**LEBANON PLANNING BOARD  
AUGUST 9, 2021 - 6:30 PM  
COUNCIL CHAMBERS, CITY HALL OR  
REMOTE VIA VIRTUAL PLATFORM  
LEBANONNH.GOV/LIVE**

**Agenda Item #3A  
Public Hearing Items**

**St. Johnsbury  
Automobile Group  
(applicant) and  
ORQT, LLC  
(property owner),  
425 Miracle Mile  
(Tax Map 103, Lot 15),  
Zoned GC  
PB2021-19-SPR**

**Mason Storage, LLC, 38 Spencer Street (Tax Map 78, Lot 39), zoned LD:** Request for Site Plan Review to construct a 15,000 sq. ft. addition to an existing warehouse building. PB2021-13-SPR

LANDSCAPE PLAN  
Prepared for:  
Labanon Ford New Addition

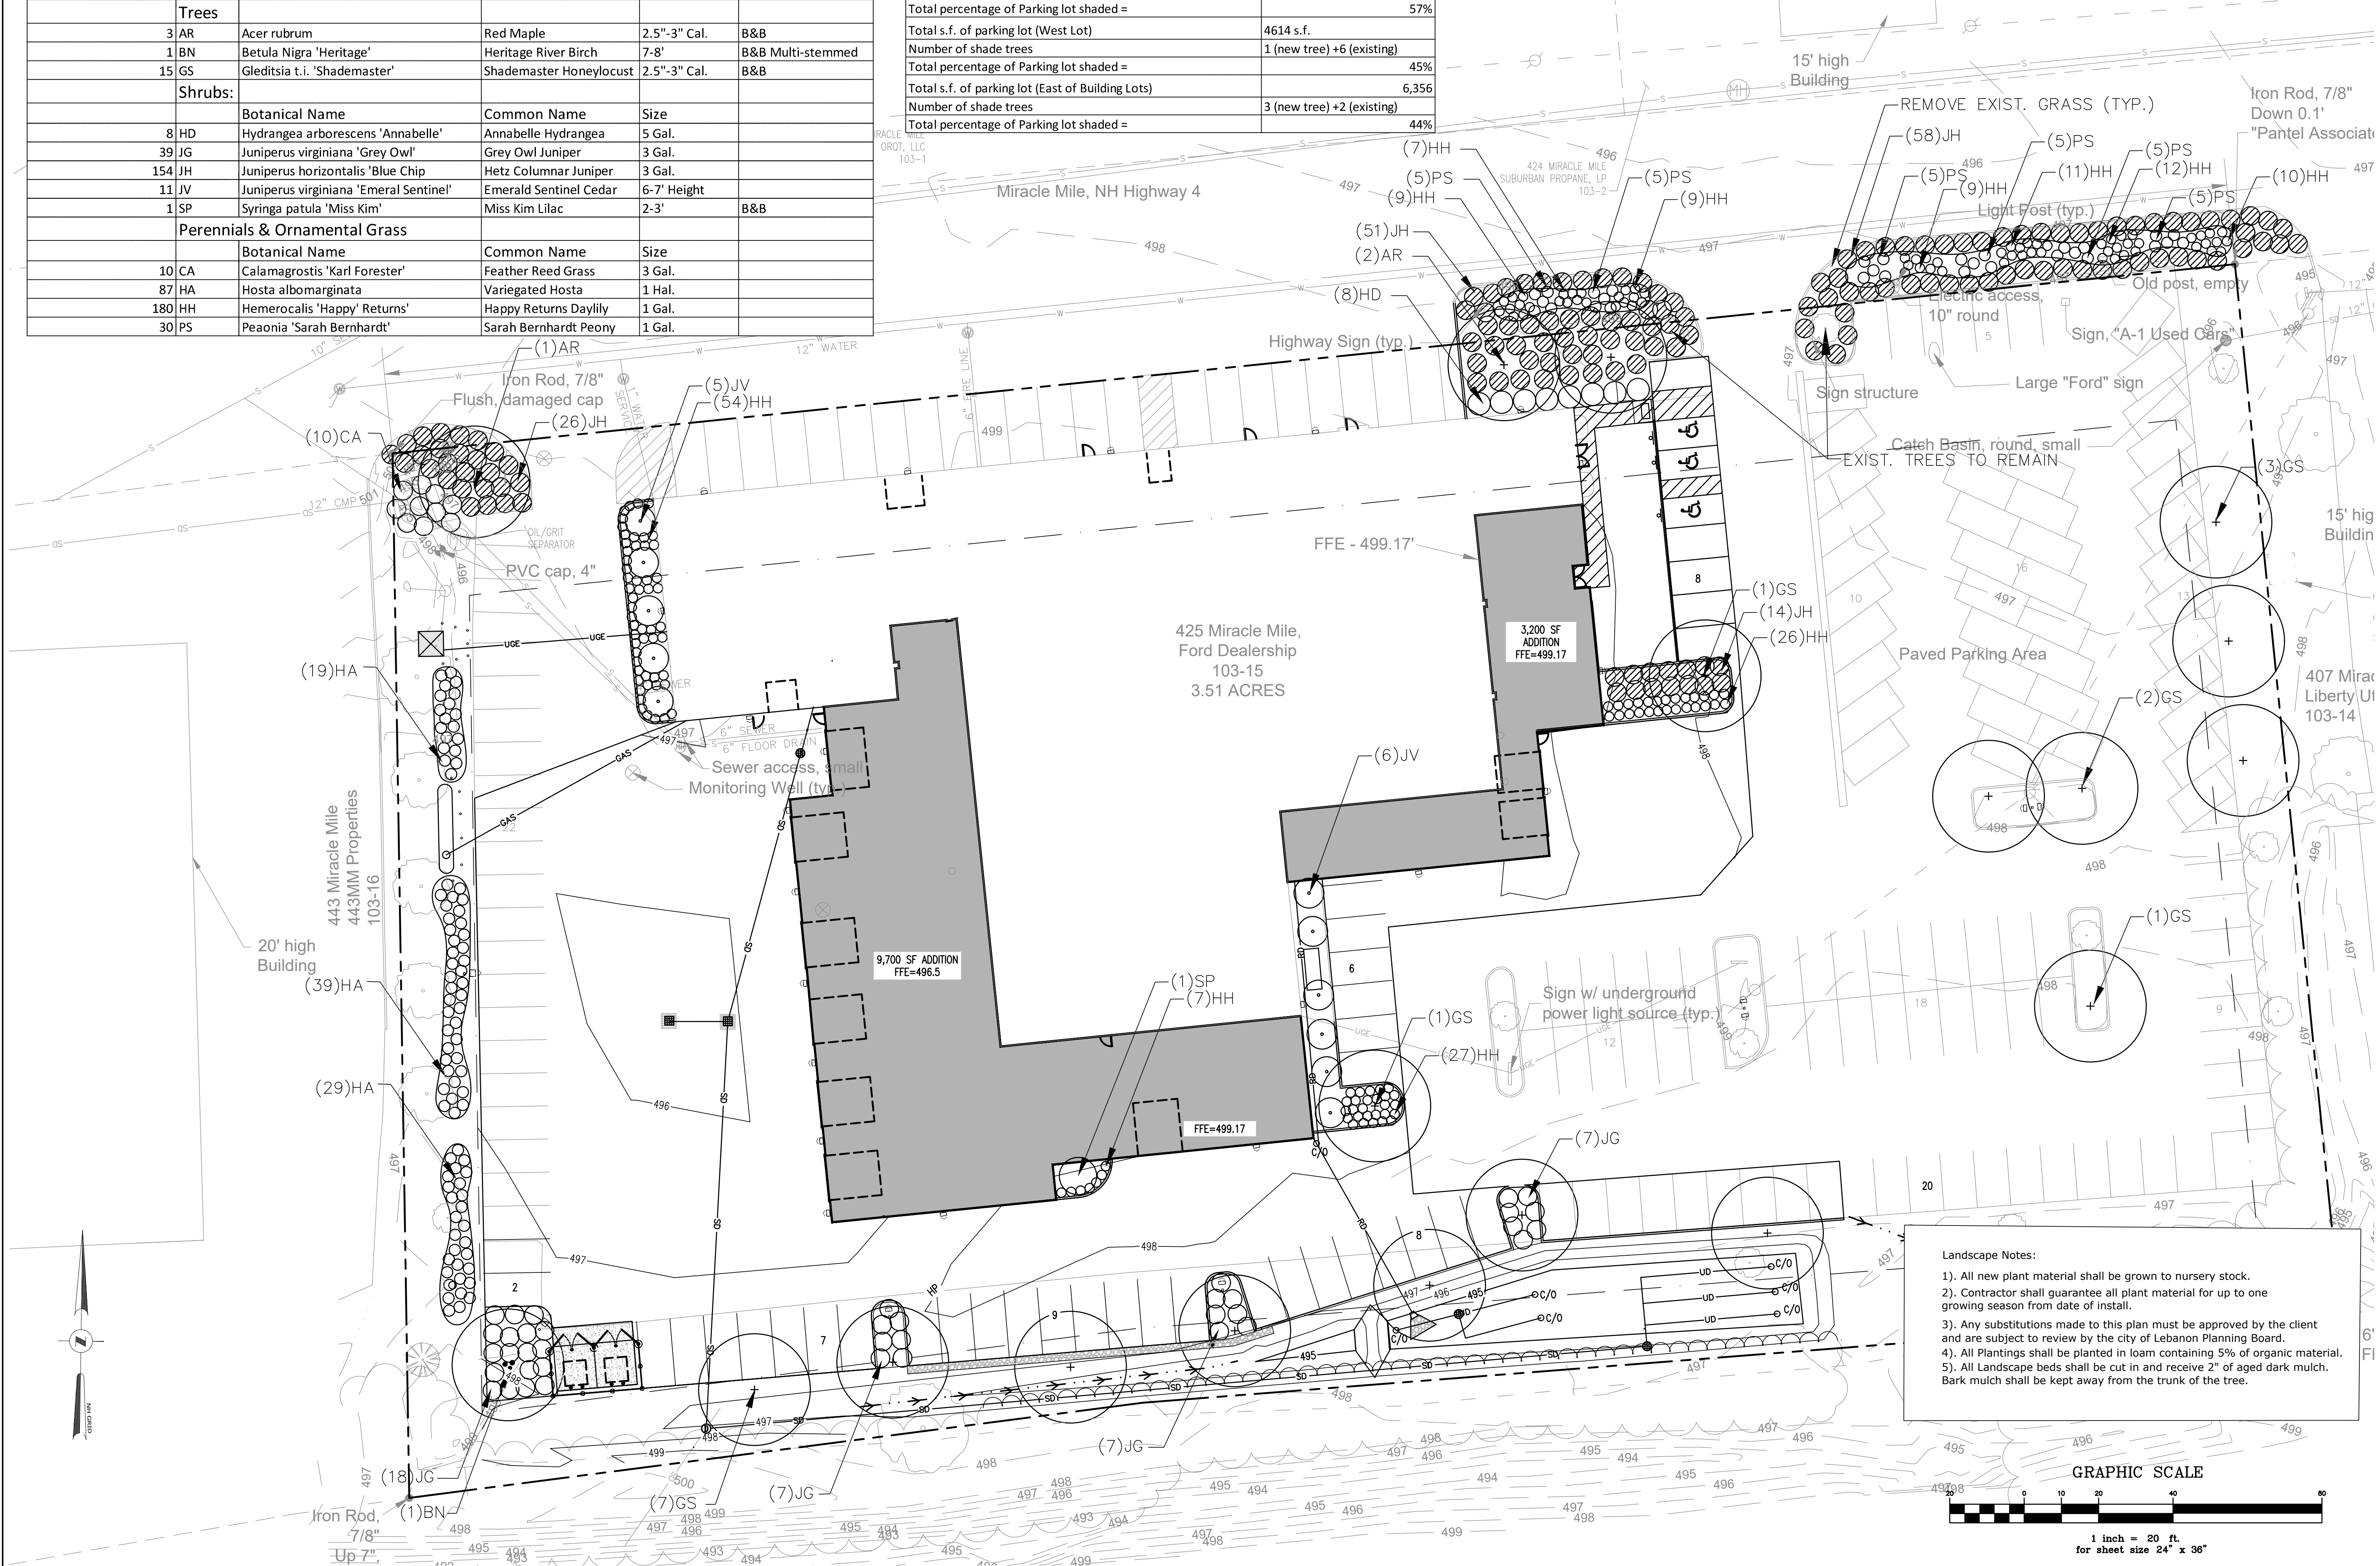
**6.2.B.1-4 – perimeter landscaping requirements:** you will note that additional landscaping has been added to the west entrance and the landscape area adjacent to the east entrance has been expanded by adding 1,000 SF. These areas are now indicated to be planted with a mixture of shade trees and shrubs to comply with section 6.2.B.1-4. The shrubs are intended to be salt tolerant in these locations to resist damage from road plowing and salting activities. You will also note that trees have been selected and placed in a manner to not restrict vehicle sight distance. As mentioned previously landscaping around the east, west and south property perimeters appears to be adequate, however, additional plantings have been added to these locations in an effort to improve shading and screening around the perimeter of the property and over parking areas. The only remaining non-conforming areas is the front of the lot that abuts Miracle Mile. Removing several additional inventory spaces at the front perimeter of the lot would cause financial hardship to the owner both for construction related costs and the ongoing profitability and operations of their business.

**6.2.B.10 – requiring trees along the front of the property, spaced no more than 40 ft. apart**  
As discussed above, trees have been added in the expanded landscape bed at the front of the property for additional screening and shading in this areas. Additional landscaping would create a hardship due to the need to maintain the existing parking at the front of the building for inventory use.

**6.2.D - landscaping around buildings requirements** Please note that on the revised plans we have greatly increased building perimeter landscaping by approximately 2,500 SF to achieve as much perimeter landscaping as possible so as to comply with section 6.2.D. Remaining areas are needed for normal functioning of the building and site circulation of emergency vehicles.

**6.2.E.1 - requires parking areas to be visually screened with landscaping (the proposed trees along the perimeter are required to be “supplemented with shrubs, perennials, or understory trees to visually screen the parking area.”)** You will note we have added additional plantings at all new bump outs adjacent to parking areas to screen these areas. The 30% shade requirement has been met or exceeded in these improved areas. Additionally, areas along the east perimeter have had shade canopy improved by the addition of 3 Honey Locust. Additional shade canopy has been added at existing interior landscape islands outside of the redevelopment area. Shade calculations are now shown on the plans.

Please note that landscaping has been added along all redevelopment areas to comply with this section. All new beds meet the minimum 8ft. width requirement and are positioned between drive isles. The entire site complies with 6.2.E.2.4 with the exception of the one row of parking opposite the patio area that is used for inventory and the row of parking in front of the building that terminates in striped hatching. The latter being necessary to support operational snow removal requirements to keep plows out of the main roadway during snow removal. Removing several inventory spaces to add additional landscape beds would be a financial hardship for the owner both for construction related costs and the ongoing profitability and operations of their business. Doing so along the building frontage would also cause a dangerous condition during snow removal.
